RECEIPT DATE: 7-15-25 ONSITE SEWAGE DISPOSAL SYSTEM P 589128

APPROVAL DATE: 8/18/2025 PERMIT: NEW CONSTRUCTION A

PROPERTY ADDRESS: 3730 Sofia Court, Glenwood, MD 21738

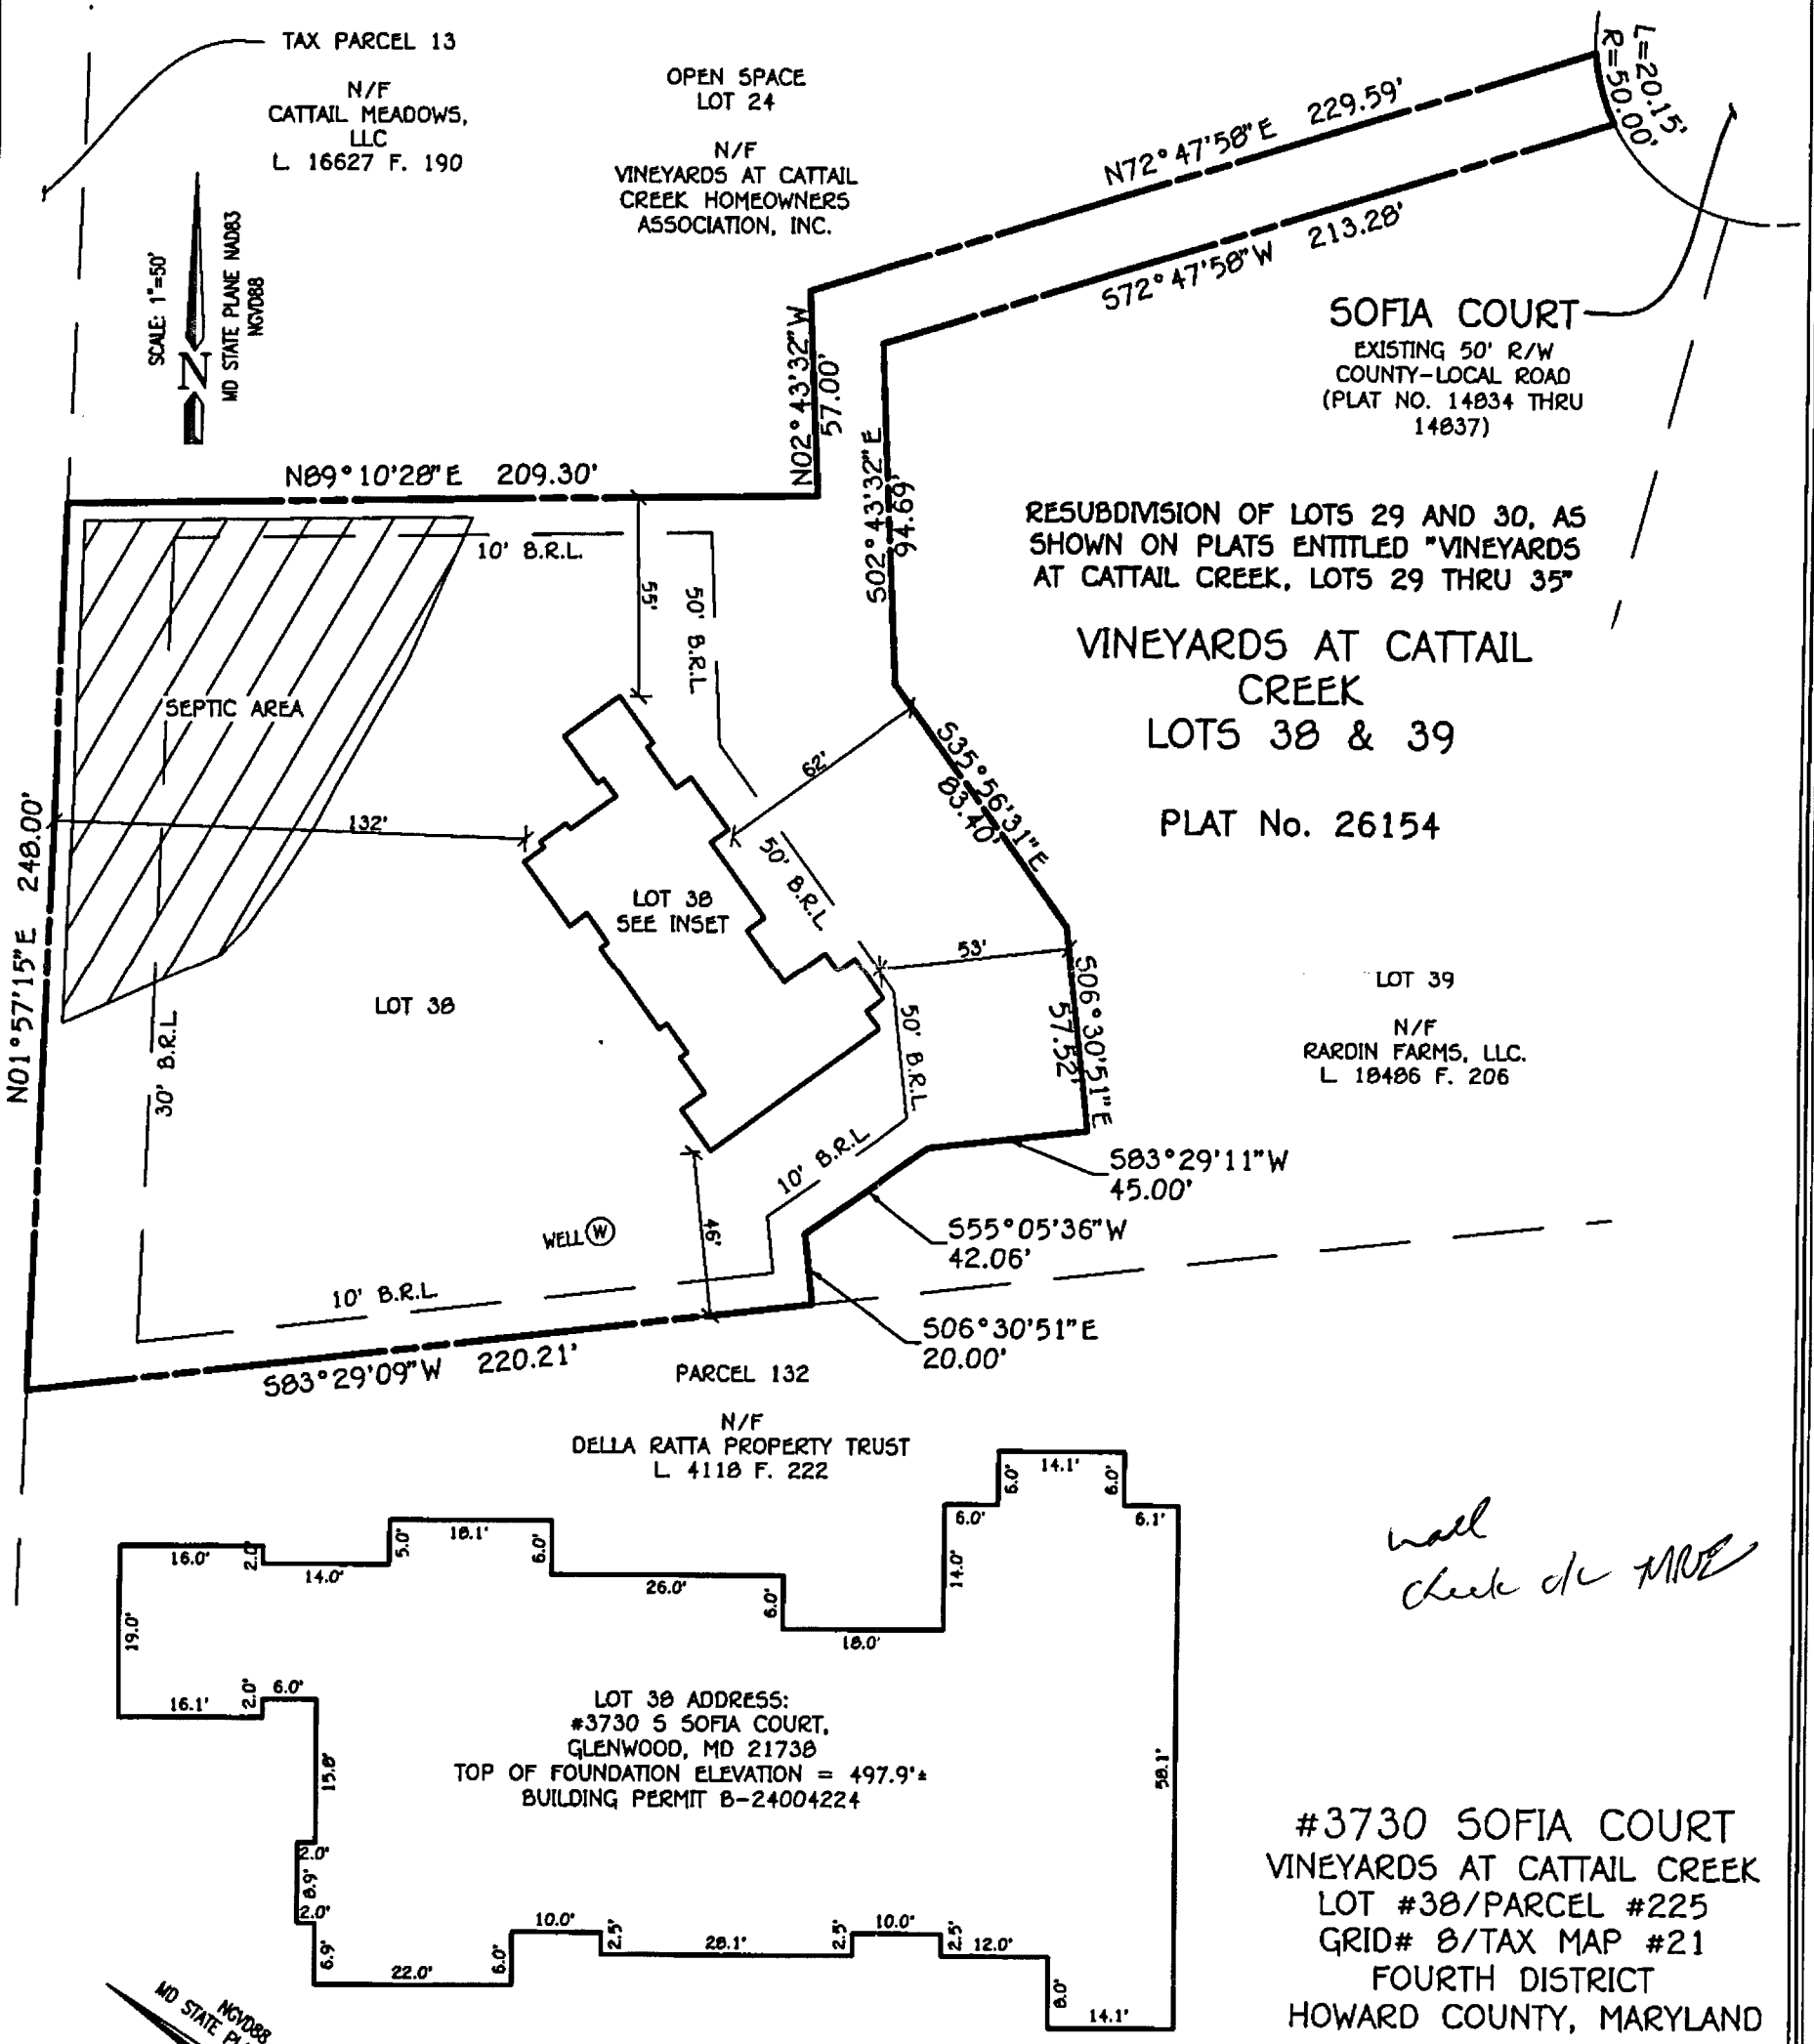
7/23/2025 - Installer onsite for pre-con, tank, trenches, & SOA spread
Silt fence installed right along bottom trench, standing water along 50' of lower trench (see attached photo).
Moved trench ~ 4' up further from standing water. trench lengths 79' each, on center within 3", & 13'-14'
report center line to center line. Installer or Builder to remove fence off SOA so water is recanted. (P)

8/15/2025 - Installer onsite for inspection. front septic line installed, alternate fall to st. 3" HD 40 PVC used. st has 6" front
baffle & 2'-1" of corr. pipe to backfill. (P)
8/18/2025 - Installer onsite for inspection. Back line installed, D-box installed. leveled d-box, 22" baffle & d-box port. trenches 78' & 210' EIE, inlet per plan. Stone & Farrow ok-ok to BAK, SM. (P)

SEPTIC SYSTEM INSTALLATION SITE PLAN
VINEYARDS AT CATTAIL CREEK
LOT 38
LEONDIRA DRIVE, GLENWOOD
ZONED RC-DEO
TAX MAP No. 21 GRID No. 08 PARCEL No. 225
FOURTH ELECTION DISTRICT HOWARD COUNTY, MARYLAND
SCALE: AS SHOWN DATE: SEPTEMBER 7, 2022
SHEET 1 OF 1

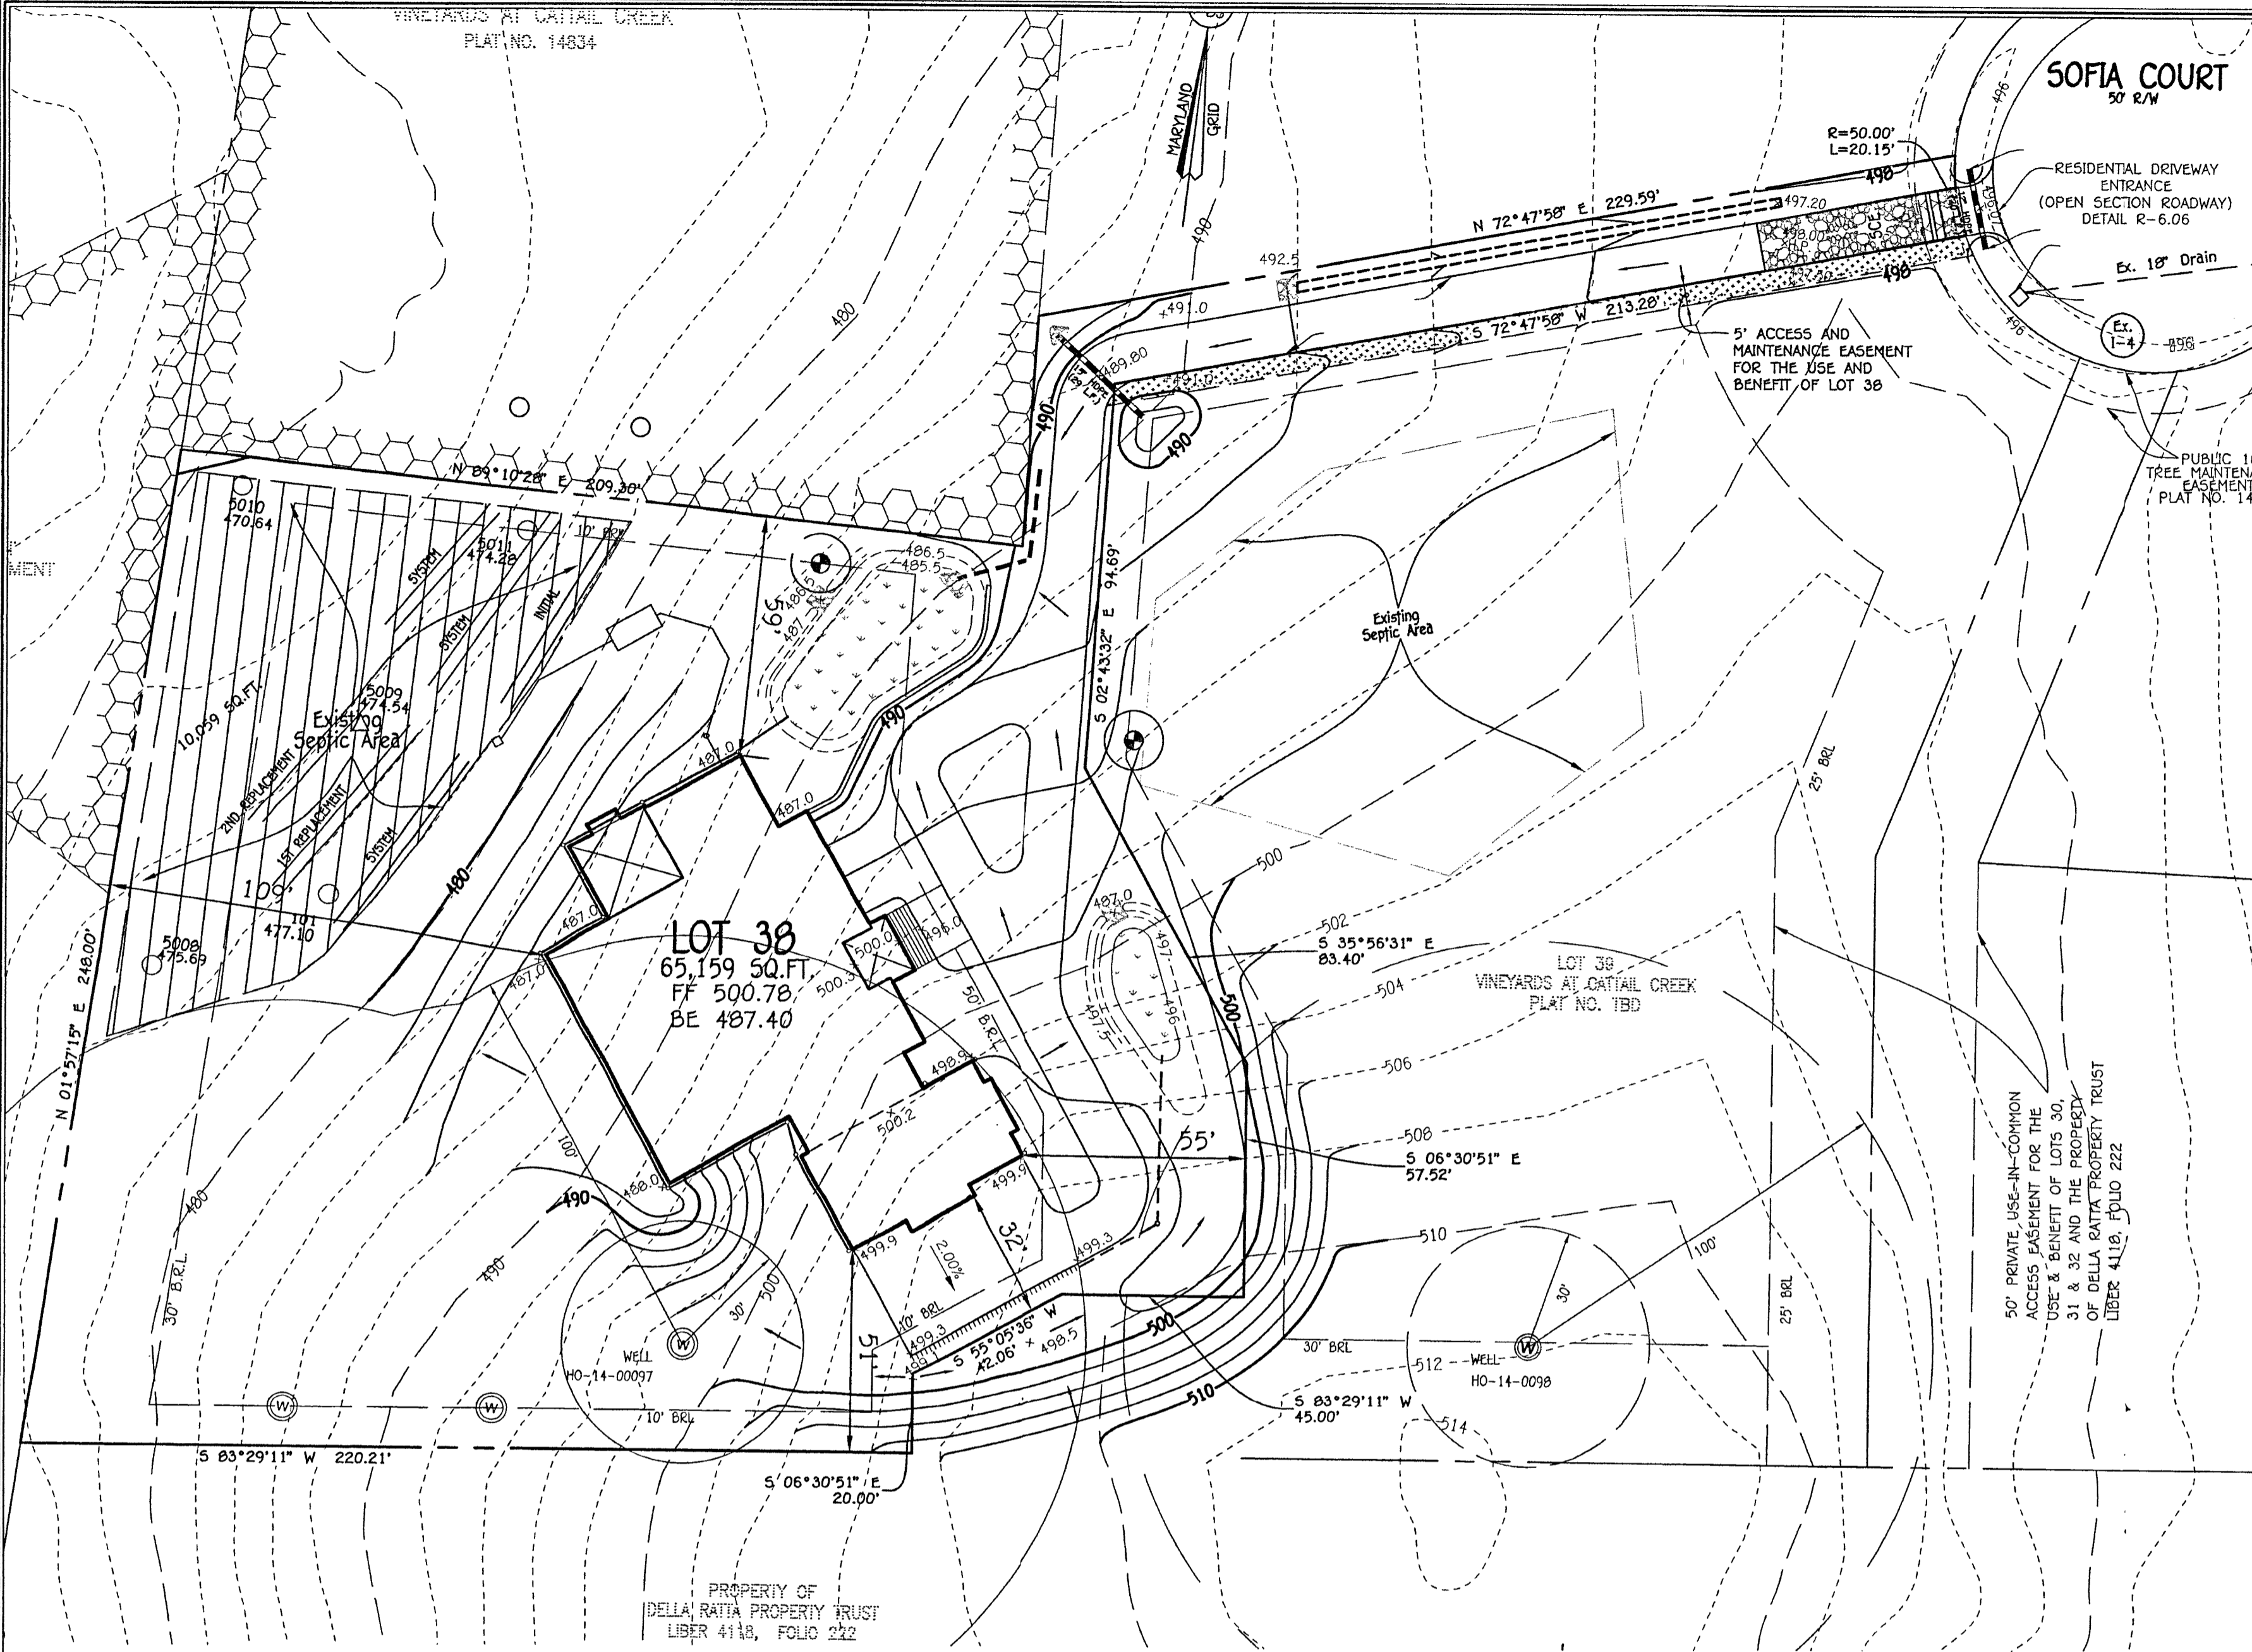
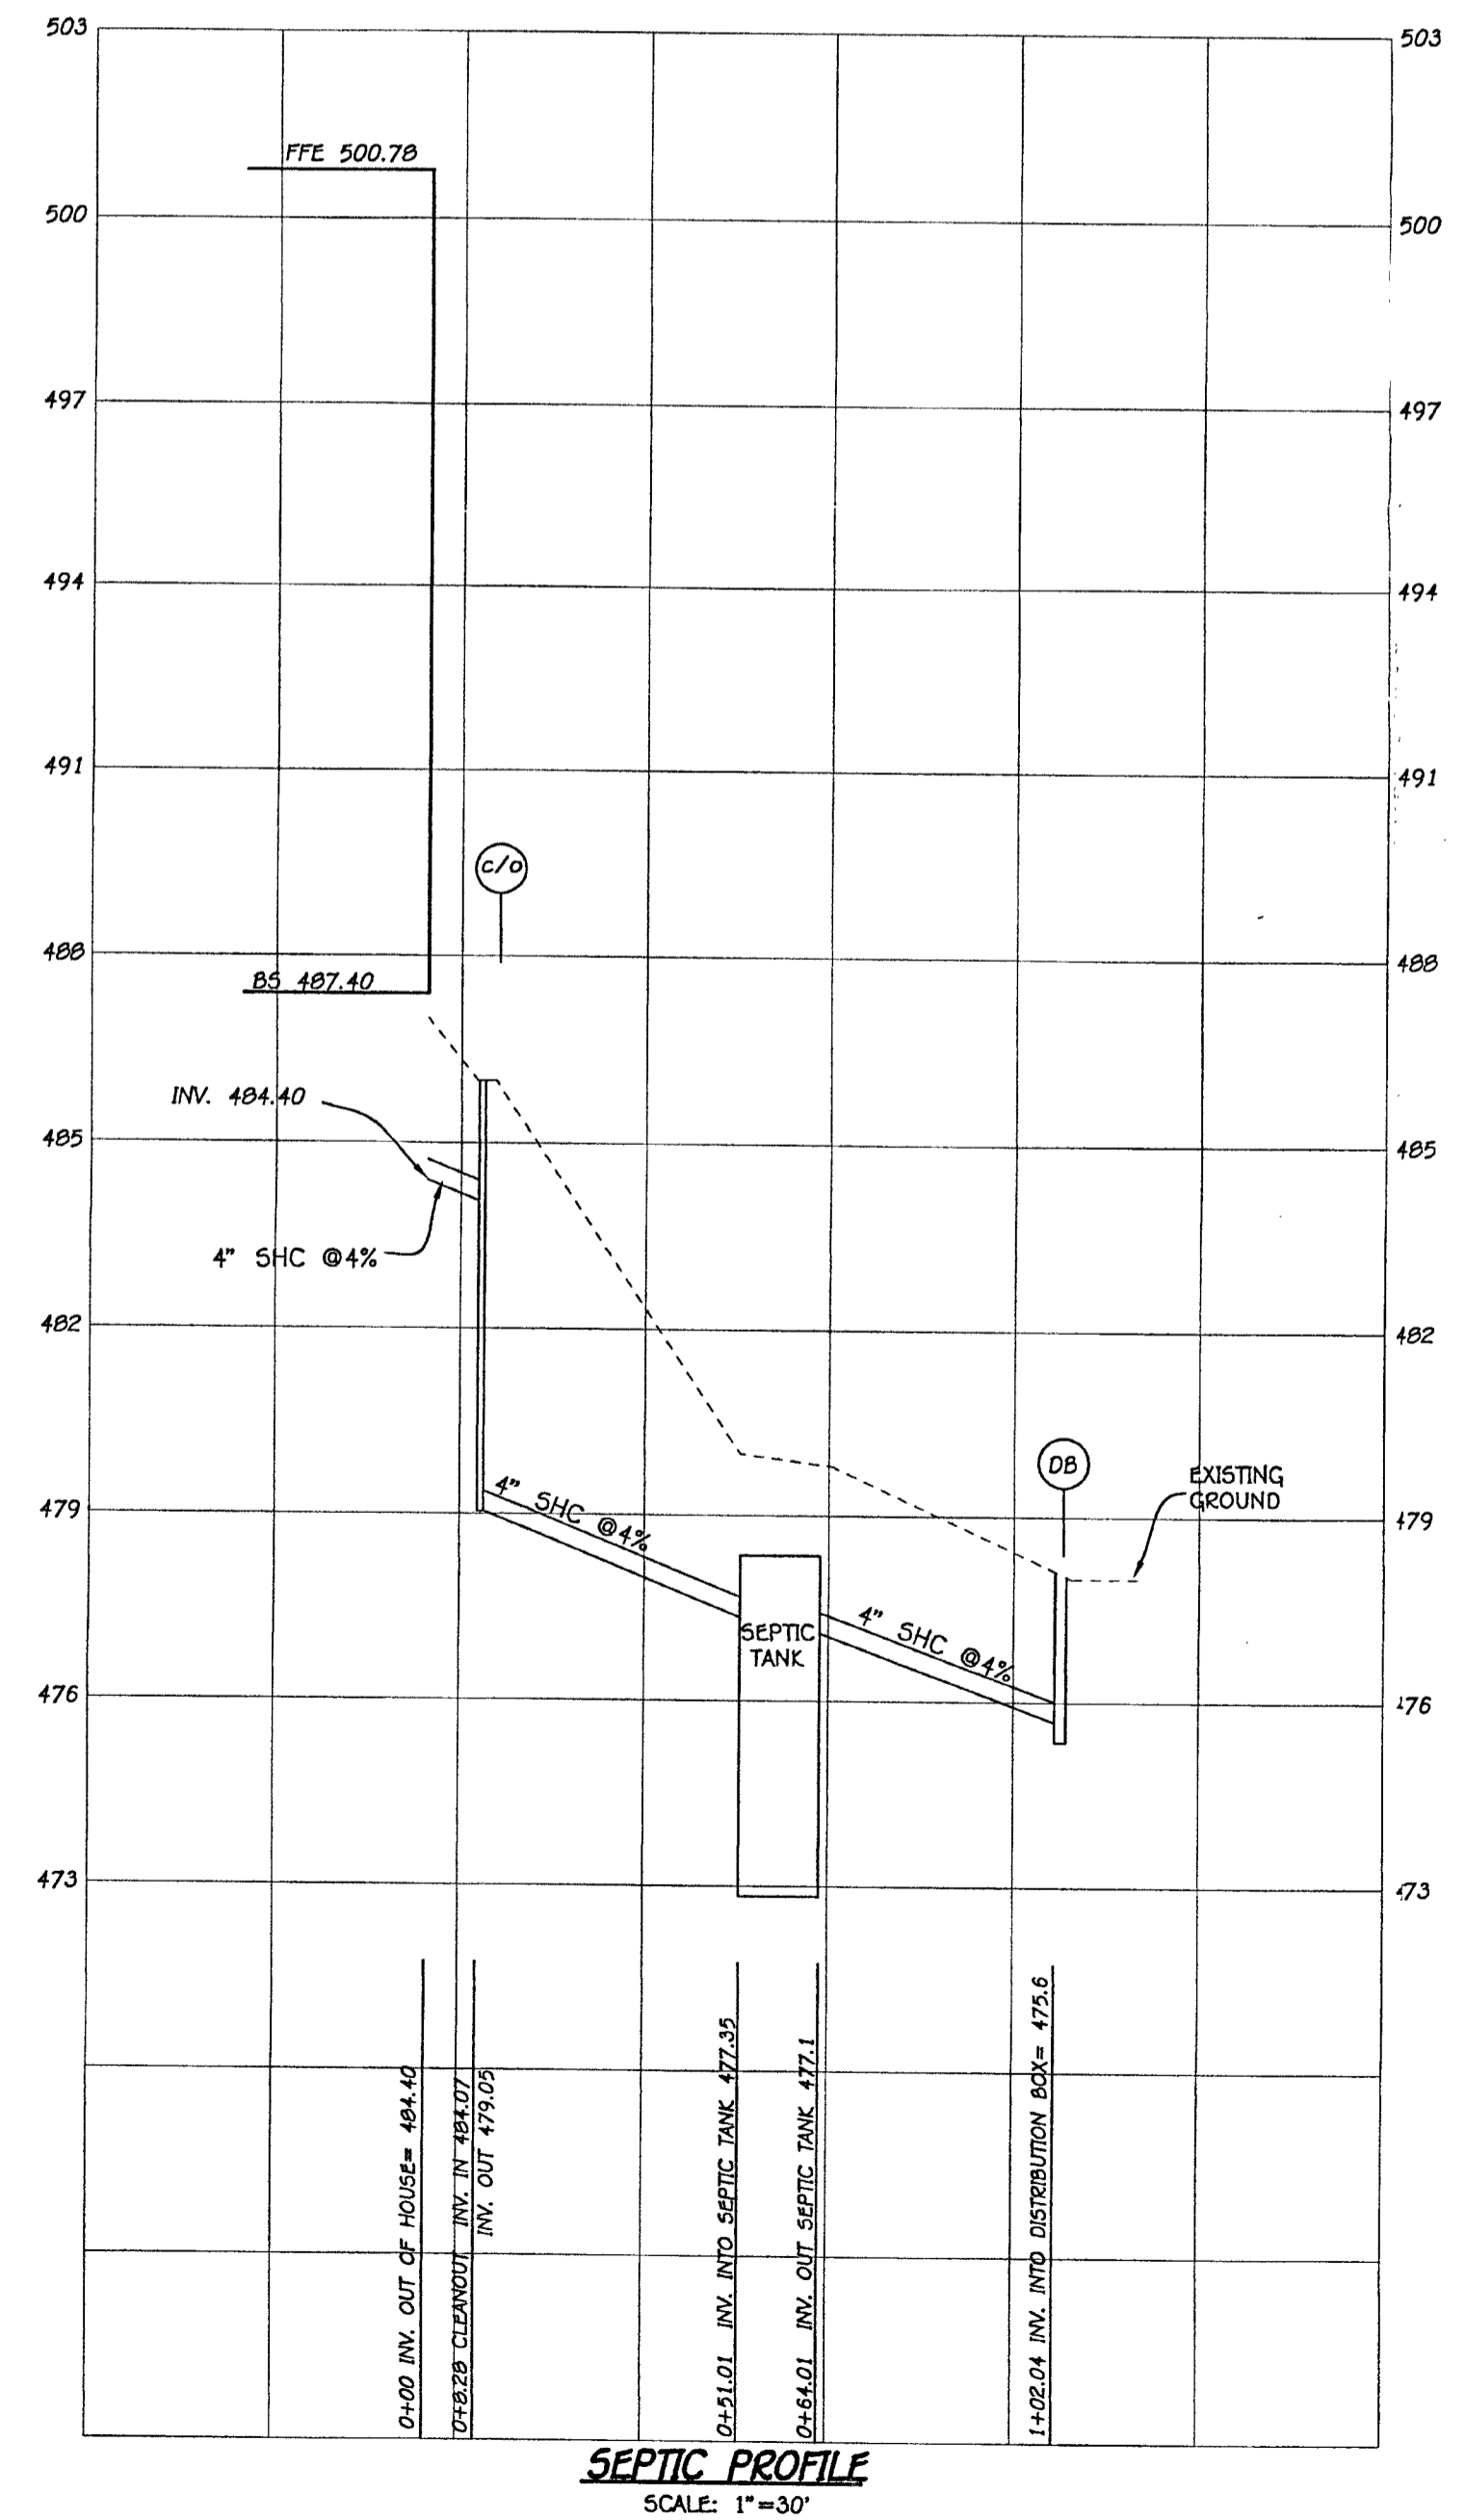
Have footprint change. OSDS Superseded By OSDS Approved 6/10/2024
